**RE: DA 2021/0317 - 141 RIVERVIEW ROAD, AVALON BEACH
SUBMISSION ON BEHALF OF NEIGHBOURS - 137 RIVERVIEW ROAD**

My wife and I am the owners of 137 Riverview Road, Avalon and together with input from a friend/architect we have reviewed drawings DA01 - DA17 and 3D artists impression all dated 22 March 2021 prepared by Fyffe Design, Statement of Environmental Effects (S.O.E.E.) dated 22 March 2021 prepared by Key Urban Planning together with the other supporting documents submitted to Council.

Architectural drawings DA04 - DA06 all show that the eastern most contour line within the site as being RL 33.00.

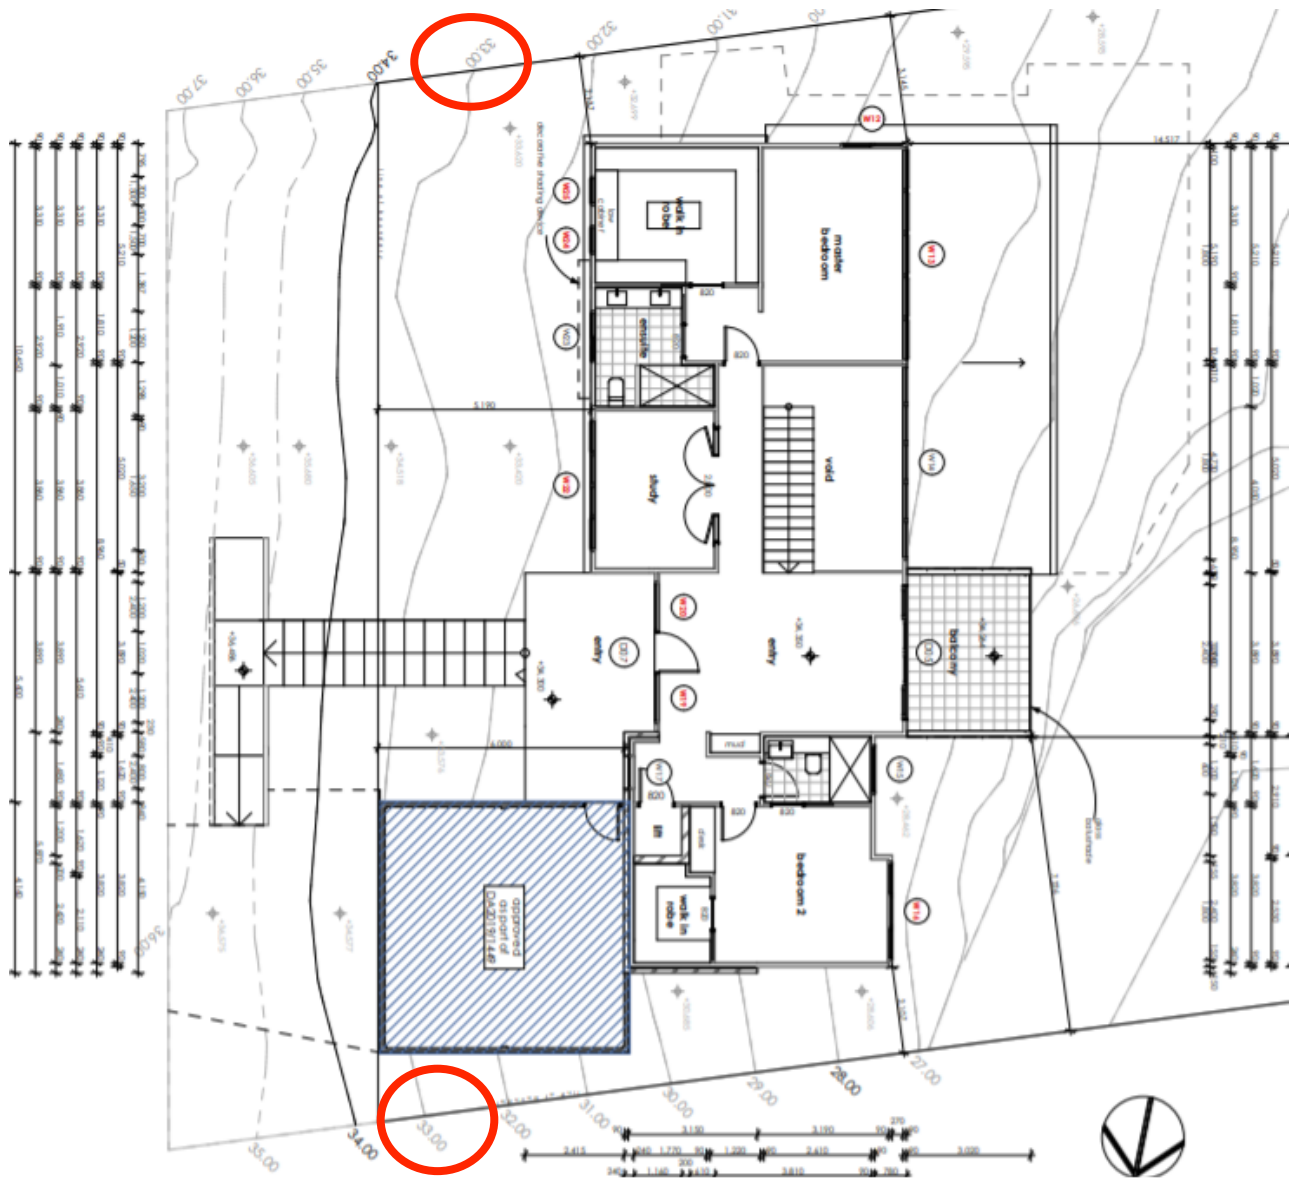
It is requested the applicant confirm which of the above RLs is correct and resubmit documentation to verify the stated "minor non-compliance"

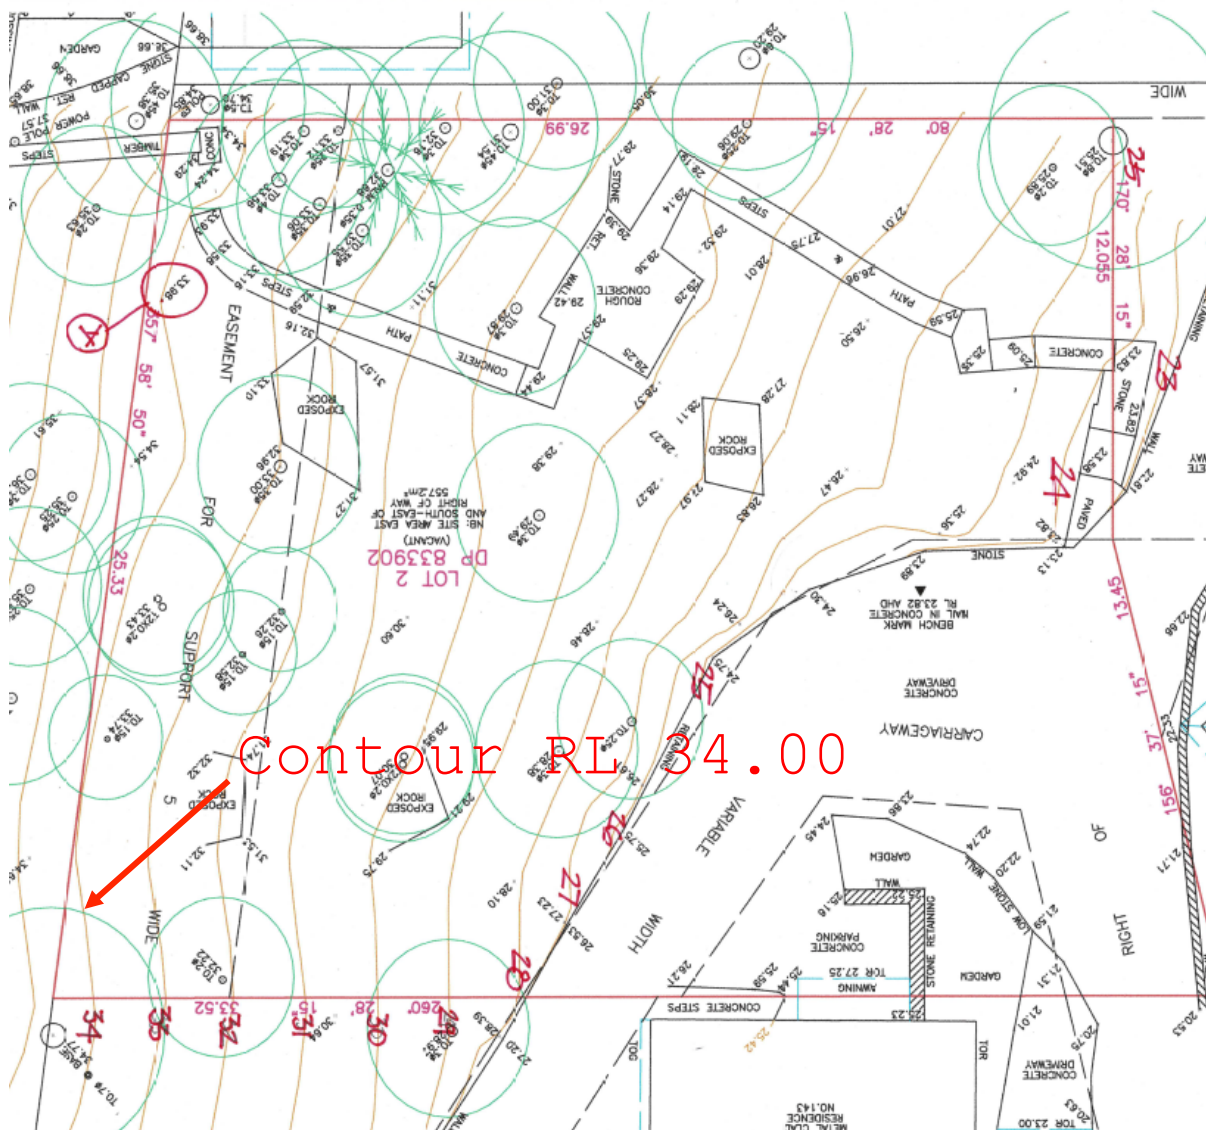
The survey prepared by D P Surveying appears to show that the eastern most contour line within the site is RL 34.00. (hand

notation by our architect having interrogated spot levels) meaning the overall development may be 1 metre higher than depicted in the drawings.

Page 40 - Arborist Report.

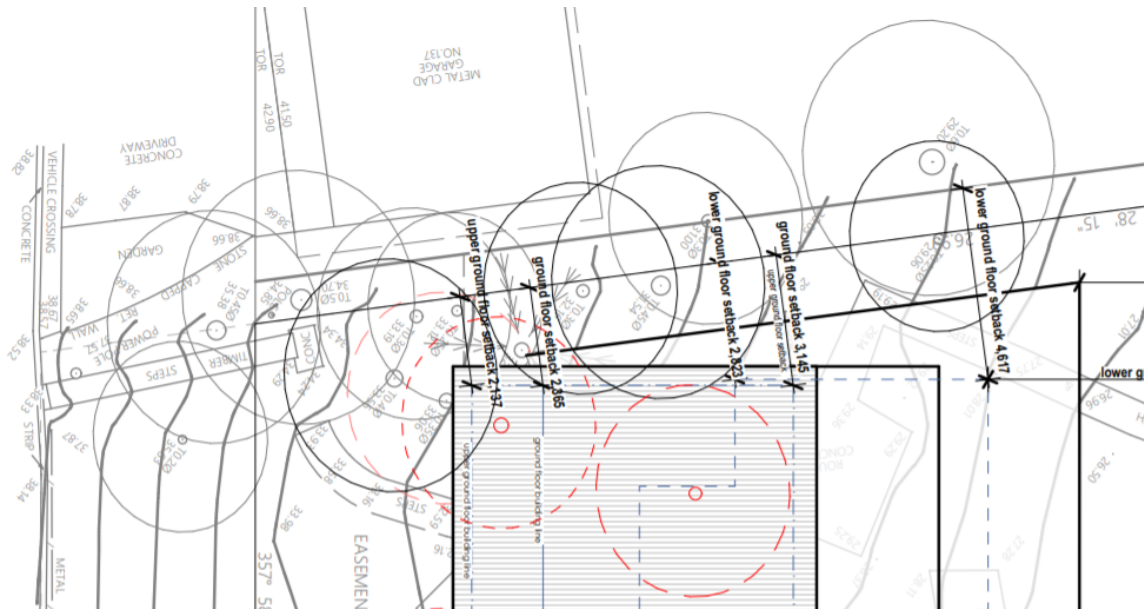
As noted in the following table, there are some differences between the trees requested and those recommended. Requested tree numbers 11 & 12 (located in Council's road easement) have not been recommended for removal, and tree 31 is noted as an exempt species, not requiring consent for removal. If tree 31, a *Pittosporum undulatum* is exempt, why are trees of the same species numbered 17 & 18 approved for removal?

Now included in the recommended consent approvals for removal are trees 26 and 33, which were not requested. Why are trees requested for retention now being recommended for removal?

Drawing DA03

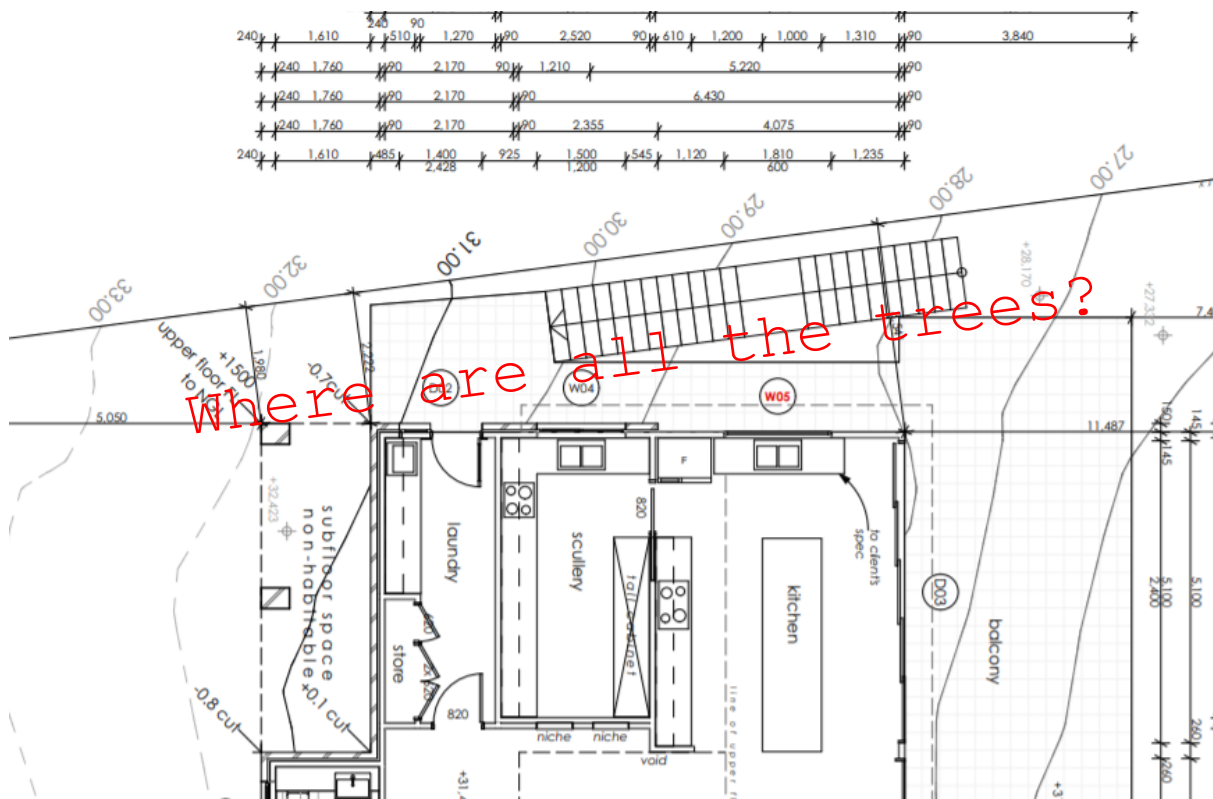
The difference in tree numbers stated above, together with drawing DA03 (below) show eight trees being retained to the south of the development yet omitting to show the Ground Floor southern balcony and access stairs depicted on drawing DA05 leads us to question exactly which trees are proposed to be removed. The statement in the S.O.E.E. "Further tree removal may be required to comply with the RFS 10:50 Code" also causes concern that this maybe used for additional tree removal.

It is requested that the applicant resubmit documentation to fully and accurately identify all trees proposed for removal.

Drawing DA02

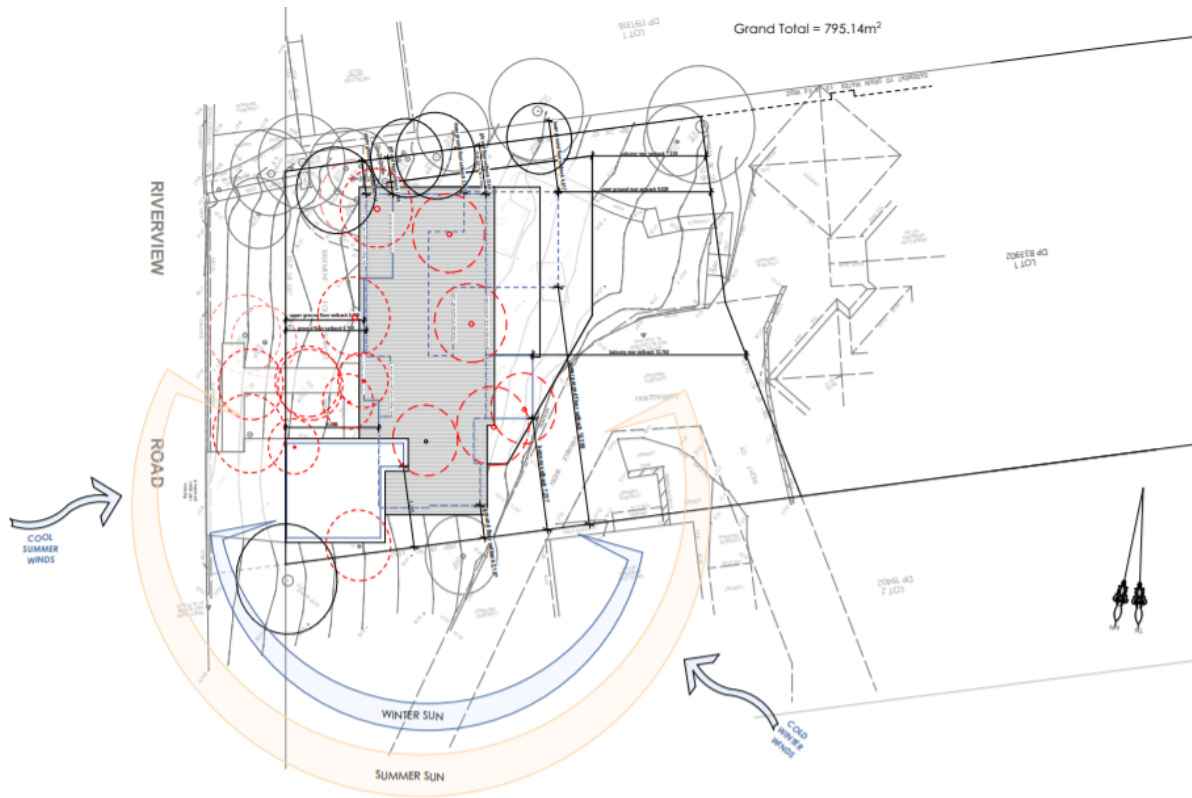
The validity of solar access documentation contained in the application is further put in doubt with drawing DA02 showing the Sun coming from the South East as opposed to drawing DA03 correctly showing the Sun coming from the North.

Architectural Drawing DA12

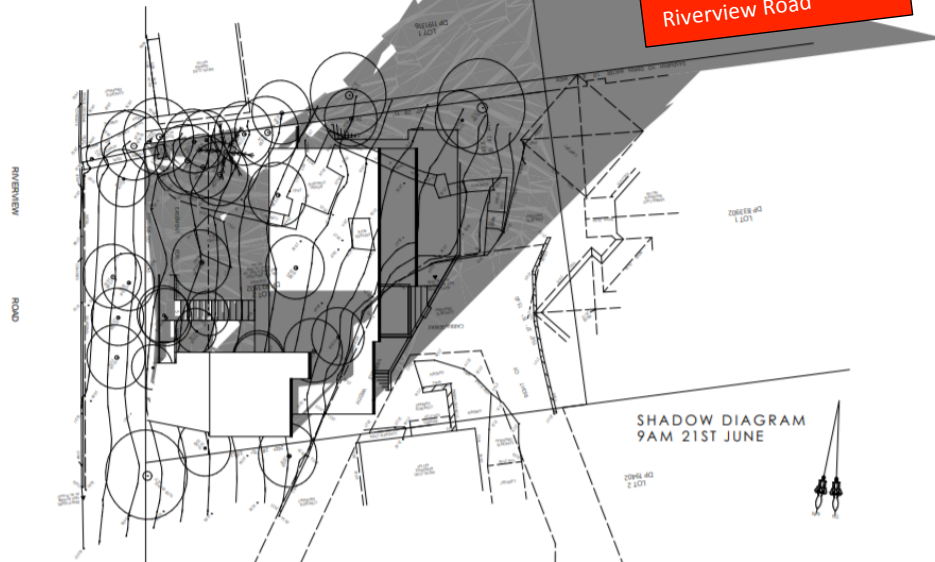
The accuracy of the 21st of June Shadow Diagram is of paramount importance to us as it appears all our morning light will be eliminated by the proposed development. Our residence has expansive full height eastern glazing that appears will be in full morning shade.

We can provide full as built drawing of our residence to the applicant's consultants to allow it to be accurately shown on the drawing DA12 to prove or otherwise, the extent of overshadowing.

The following diagram indicates the approximate position of our residence.
